# Access Compliance Report

## Public Rights-of-Way

Intersection ID: 3919	Main Street: MOUNTAIN_PARK_DR	Cross Street: MT_ISLE_HARBOR_DR	Location: SE
ADA ID: F9A76233BFBD	Ramp Type: Perp	Initial Pass/Fail: Fail	Overall Compliance: No
Severity Score: 12.5			
Codes/Mitigation Info/Possible Solution		Field Measurements/Component Compliance

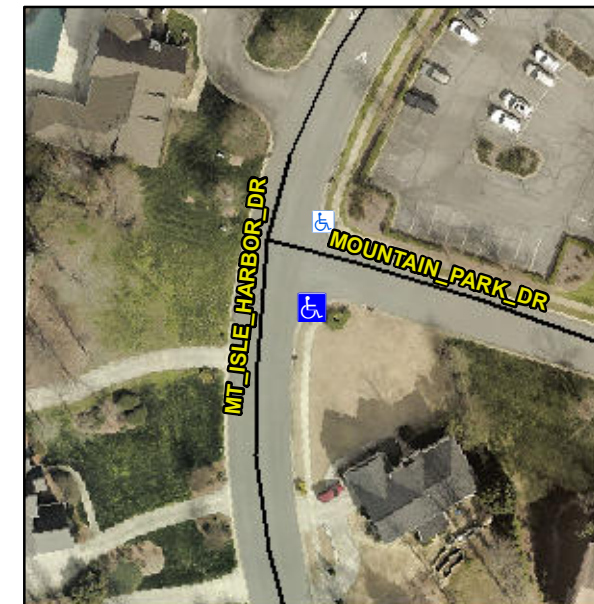
**Not Found, R304.2.2**

Compliance	Description	Data	Compliance	Description	Data
N/A	Ramp Length (in)	52.0	No	Ramp Slope (%)	9.9
Yes	Ramp Width (in)	48.0	Yes	Ramp XSlope (%)	1.9
N/A	Flare Type LT	N/A	N/A	Flare Type RT	N/A
N/A	Flare Slope LT (%)	N/A	N/A	Flare Slope RT (%)	N/A
N/A	Flare Traversable LT?	N/A	N/A	Flare Traversable RT?	N/A
N/A	Landing Length (in)	N/A	N/A	DWS Provided?	N/A
N/A	Landing Width (in)	N/A	N/A	DWS Contrast?	N/A
N/A	Landing Slope (%)	N/A	N/A	DWS Length (in)	N/A
N/A	Landing X Slope (%)	N/A	N/A	DWS Full Width?	N/A
N/A	Landing Curb? (Y/N)	N/A	N/A	DWS Offset (in)	N/A
N/A	Shared Landing?	N/A			
N/A	Gutter Ponding?	N/A	N/A	Gutter Slope (%)	N/A
N/A	Gutter Lip Ht (in)	2.0	N/A	Gutter X Slope (%)	N/A
N/A	Painted X Walk1?	No	N/A	Painted X Walk2?	N/A
	X Walk 1 Direction	To N		X Walk 2 Direction	N/A
N/A	X Walk 1 Width (in)	N/A	N/A	X Walk 2 Width (in)	N/A
	X Walk 1 Slope (%)	1.9		X Walk 2 Slope (%)	N/A
	X Walk 1 X Slope (%)	1.1		X Walk 2 X Slope (%)	N/A

**Remove & Replace Entire Ramp.**
